**APPLICATION FOR
URBAN DESIGN COMMISSION
REVIEW AND APPROVAL**

PROJECT ADDRESS: 2501 AND 2601 WEST BELTLINE HIGHWAY
ALDERMANIC DISTRICT: 14

Re: Letter of Intent for an amendment to the approved Comprehensive Signage Package at Arbor Gate
Project No. 2004.06.10

Type 8-6: Projecting blade sign

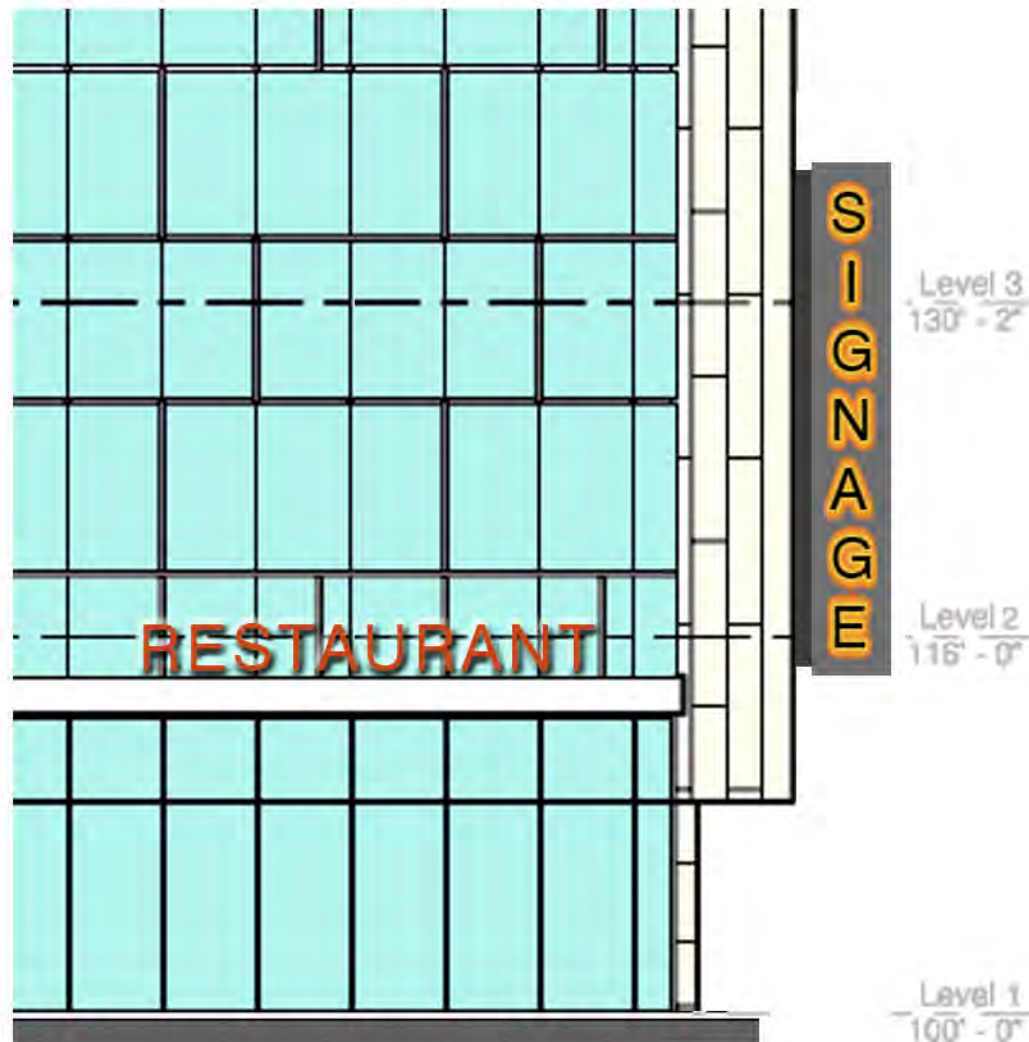
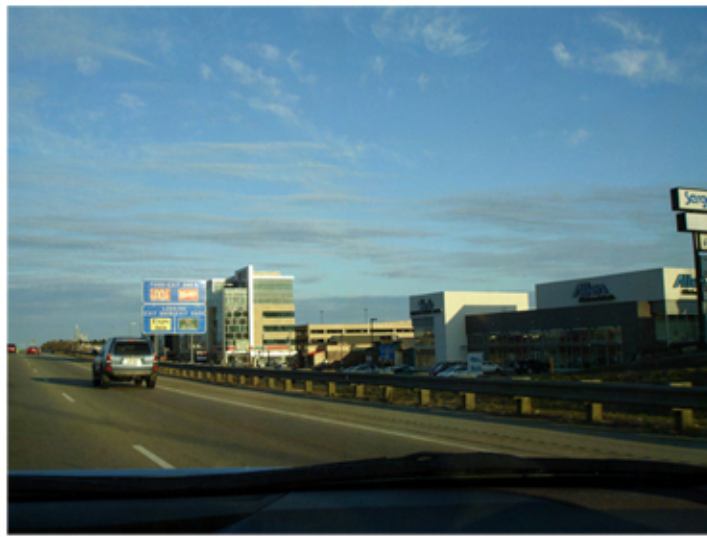
Approved blade sign concepts are the same as the building signage concepts above with the following additions:

1. Blade sign may be internally fluorescent or LED-lit
2. Blade sign may include tenant's logo/corporate identify element only
3. Blade sign may be single- or double-sided
4. All sides of blade sign must be metal and be finished to match the tenant's building signage or the approved building standard finish
5. The permitted maximum face size of the blade sign is three feet (3') wide by twenty-one feet (21') high
6. Blade sign may be oriented from 45 degrees (diagonal) to 90 degrees (perpendicular) to the major façade of the building and must be a minimum twelve inches (12") deep

Drawing Title
**Exterior Signage
 West Elev
 Option B**

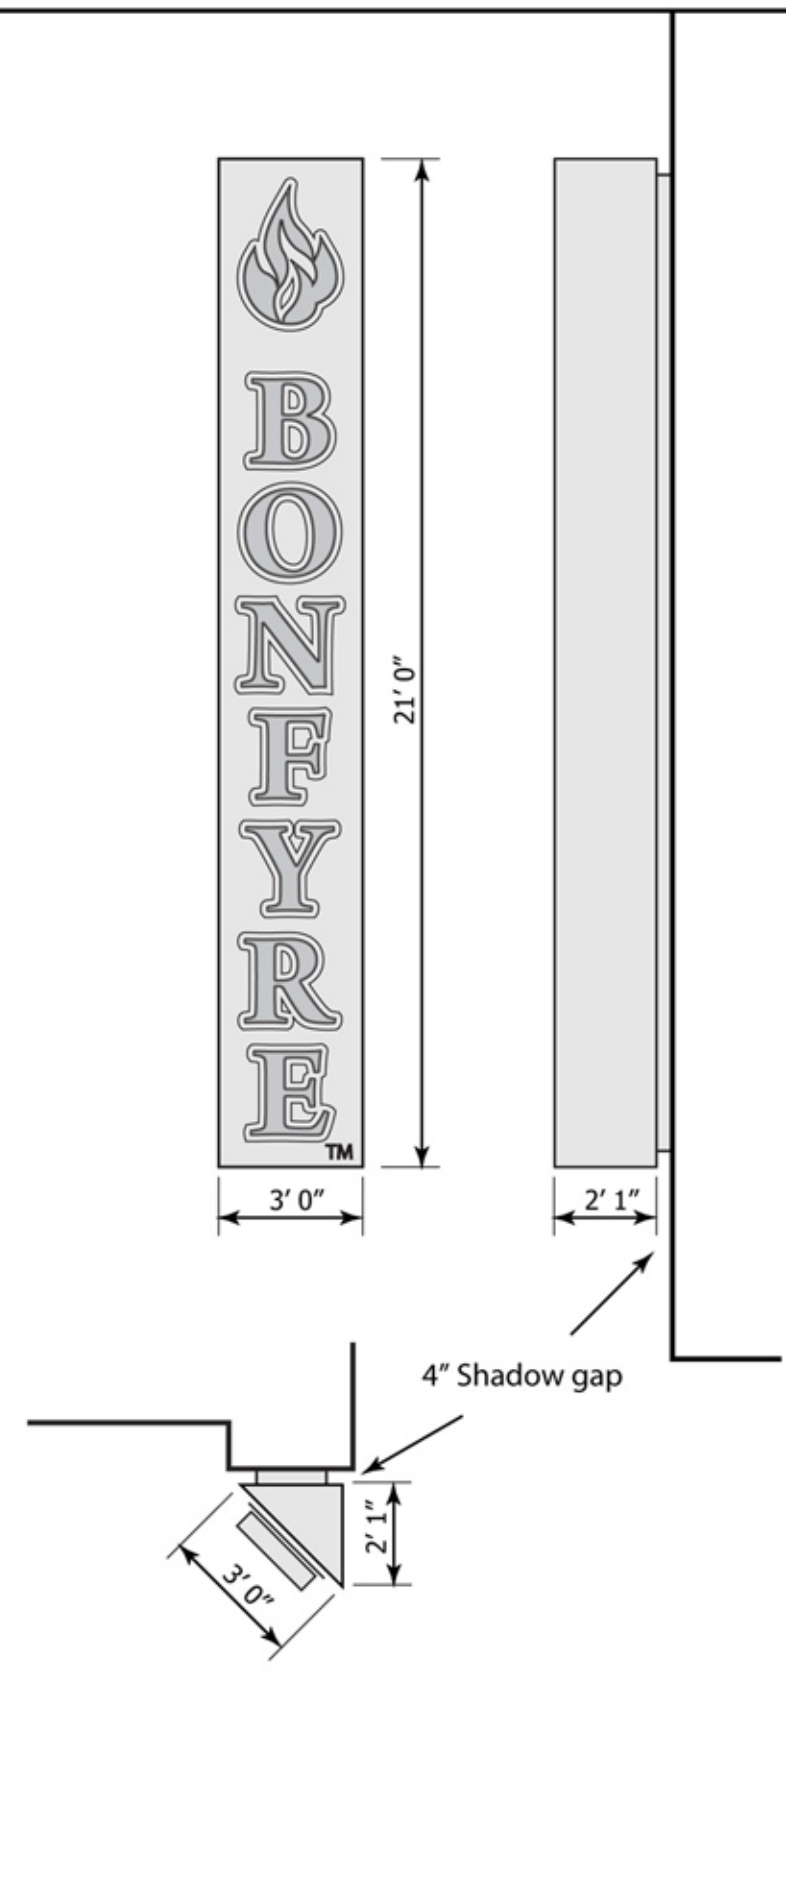
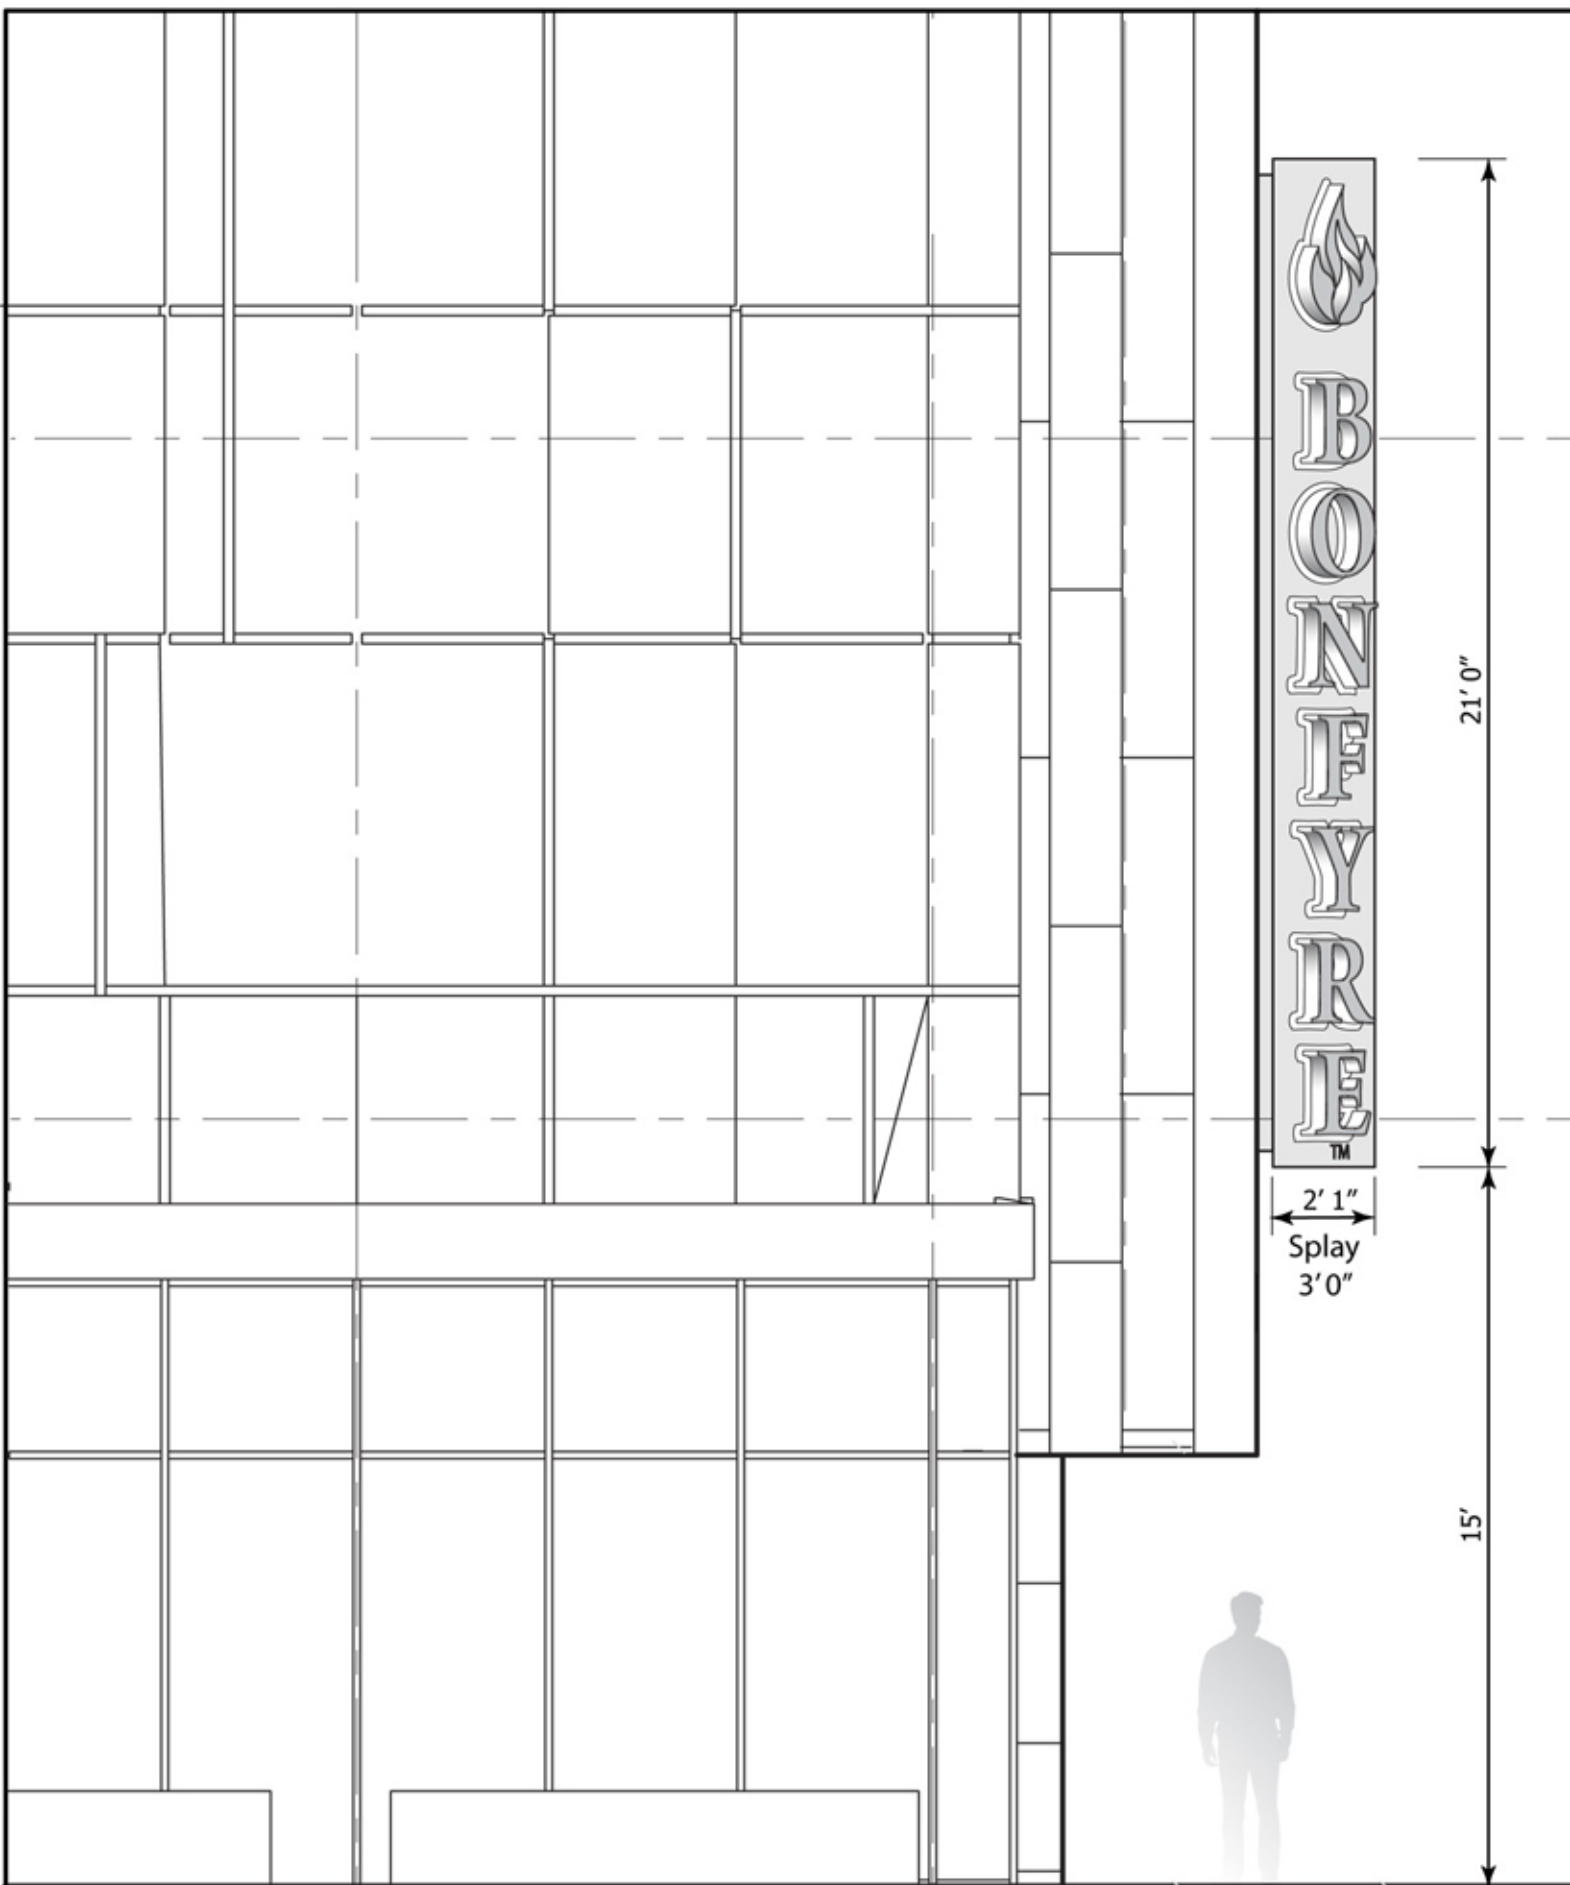
A	3/29/2010	Bottom of sign now at 15'
Rev	Date	Note

Drawing Title
**Plan Location Northwest
Corner Arbor Gate
Option B**

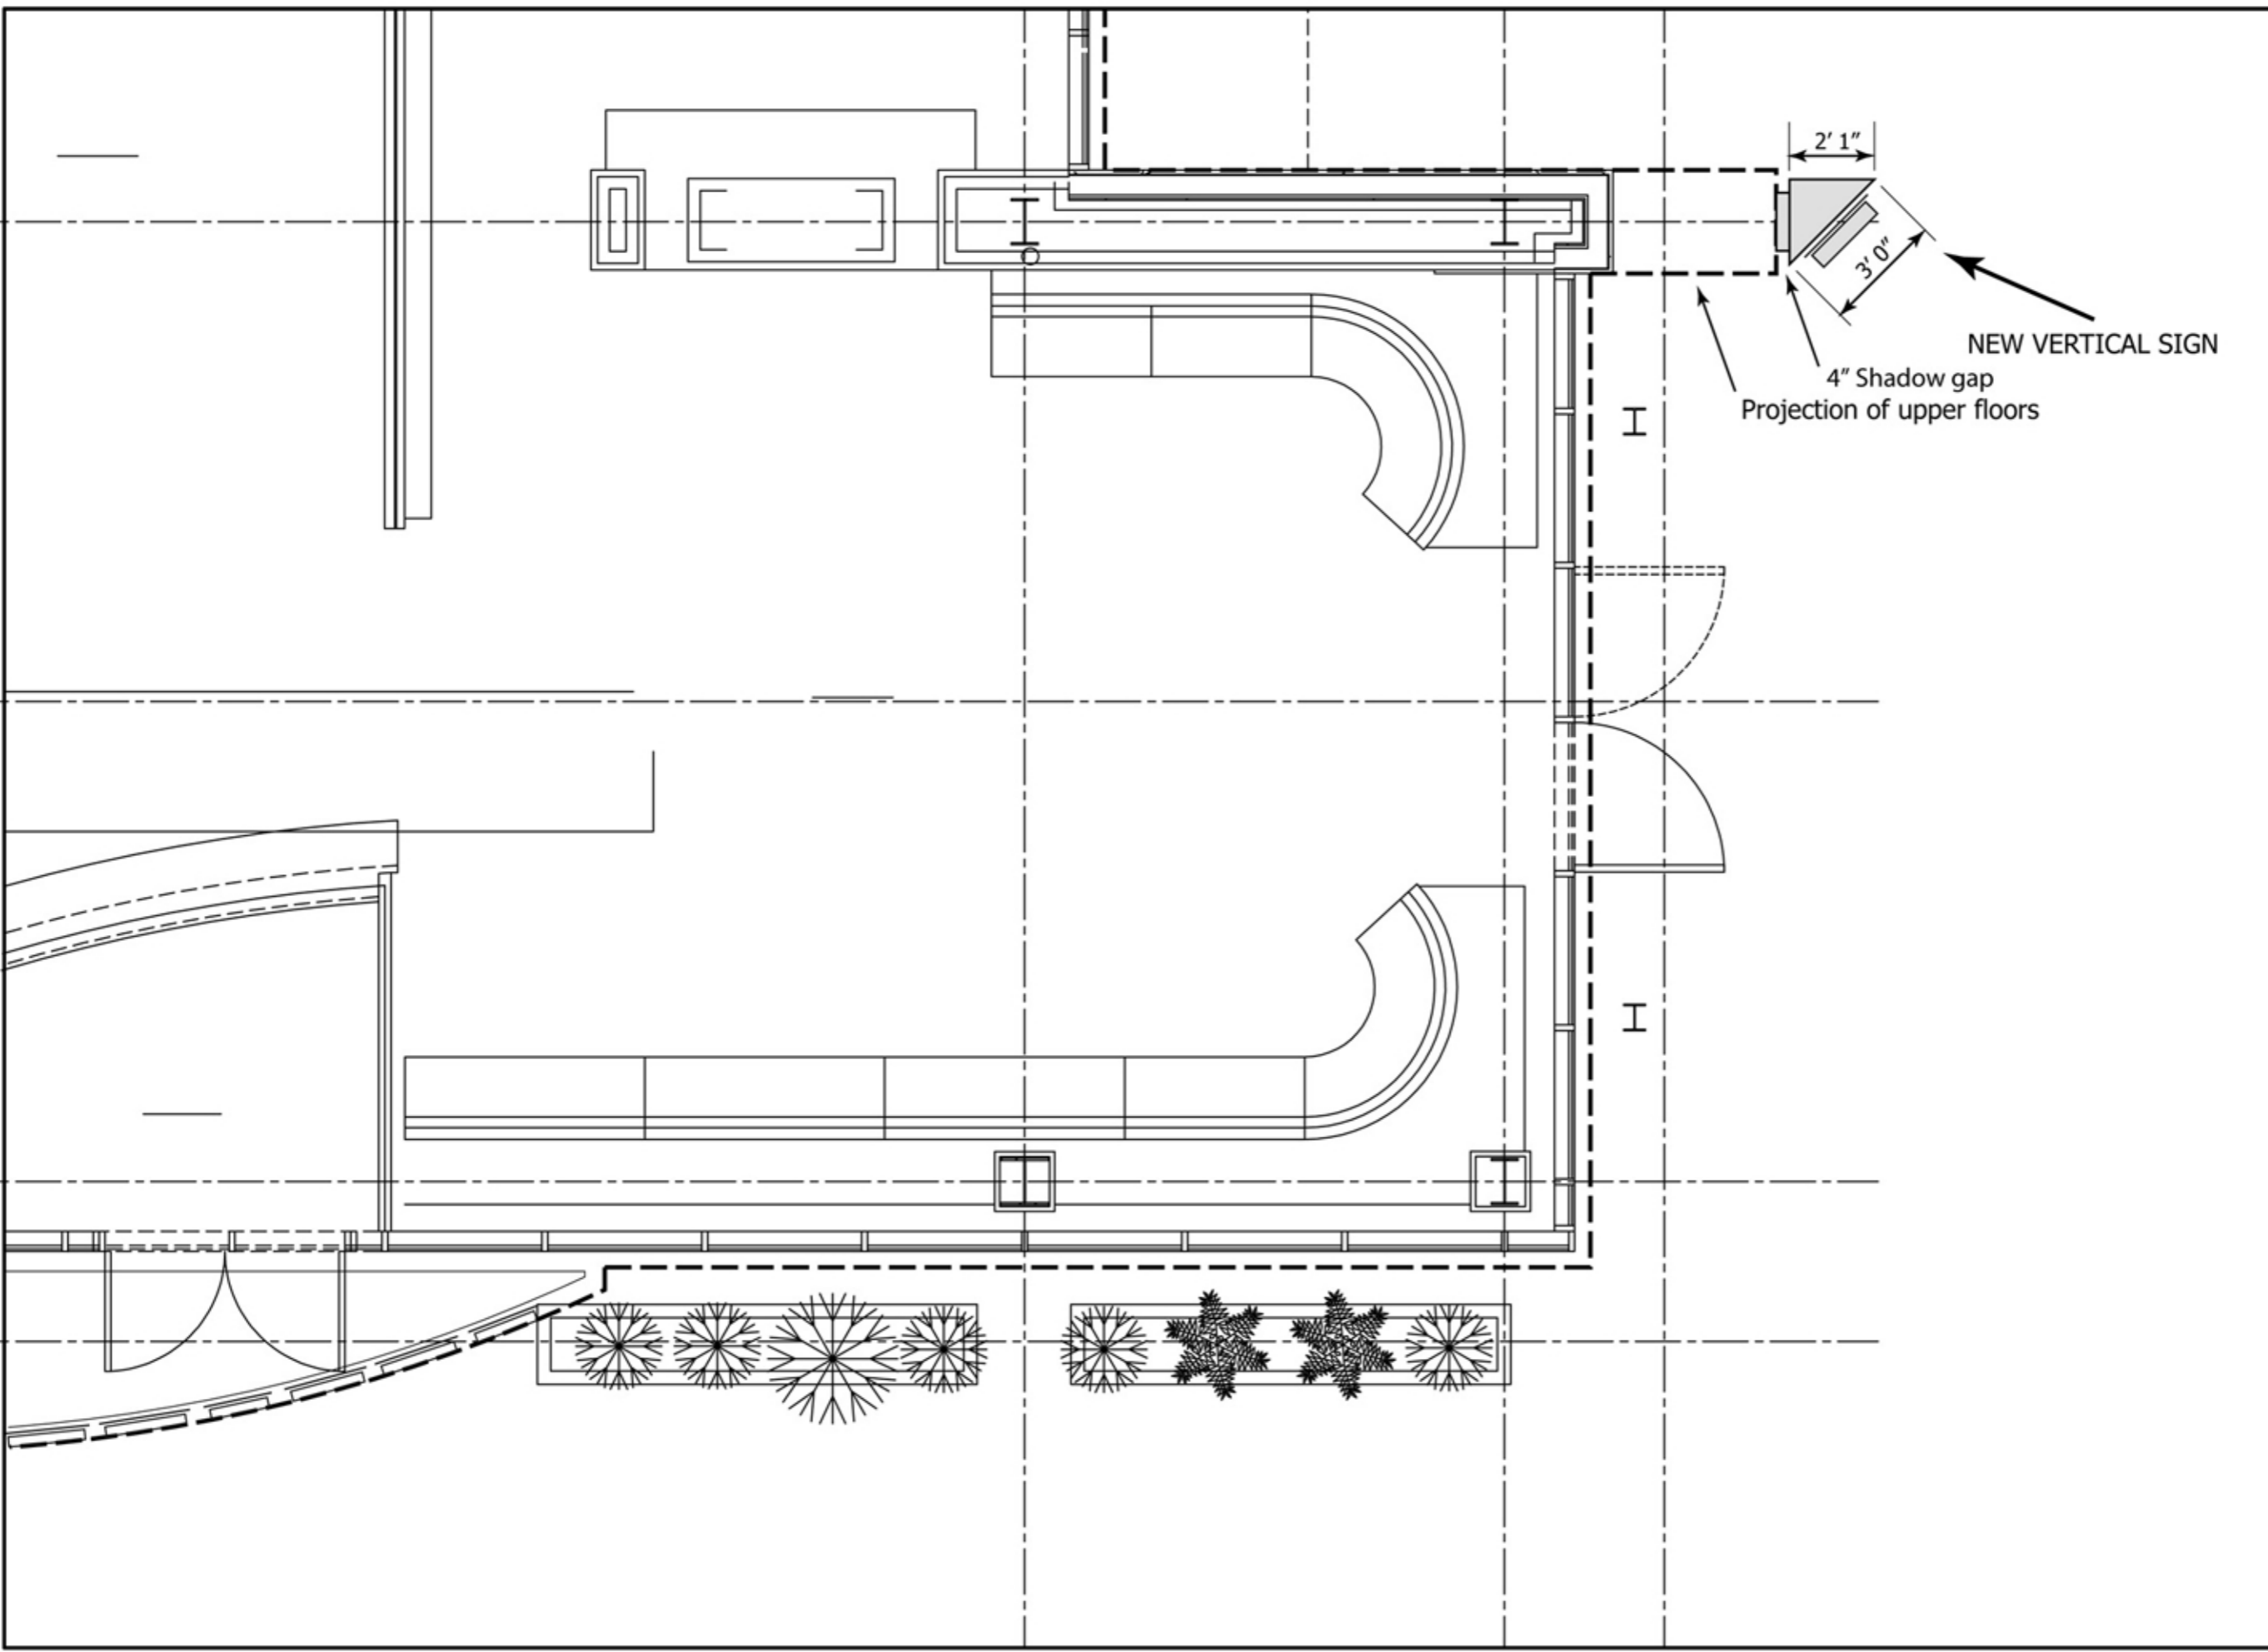
Rev	Date	Note
A	3/309/2010	Facade projection shown 4" shadow gap added

Drawing Title
**Exterior Signage
Vertical Sign Specification
Option B**

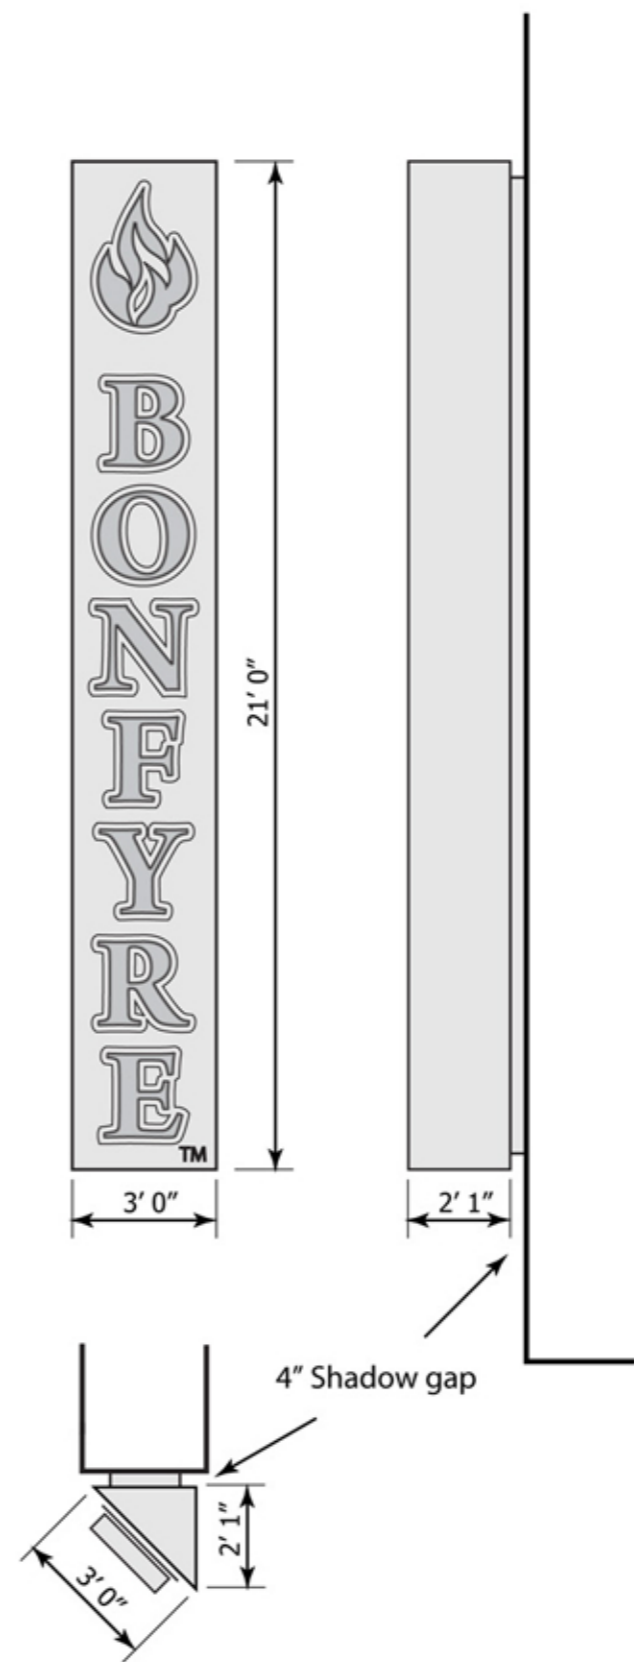
Rev	Date	Note
A	3/30/2010	4" Shadow gap detail

TRIANGULAR PRISM-SHAPED VERTICAL SIGN To be mounted to the buildings' structural steelwork. The internal structure of the sign is to be a steel frame designed to withstand severe wind loads. The sign is to be clad in brushed aluminum.

LETTERS - 24" tall backs of letters to be cut in brushed aluminum plate spaced with a gap to the body of the sign. 21" fronts of letters are to be spaced with a gap from the backs and internally illuminated with LEDs to create a halo effect. Sides formed in aluminum to create 3-D letters 4" deep. Fronts of letters to be burgundy red acrylic internally illuminated by LEDs.
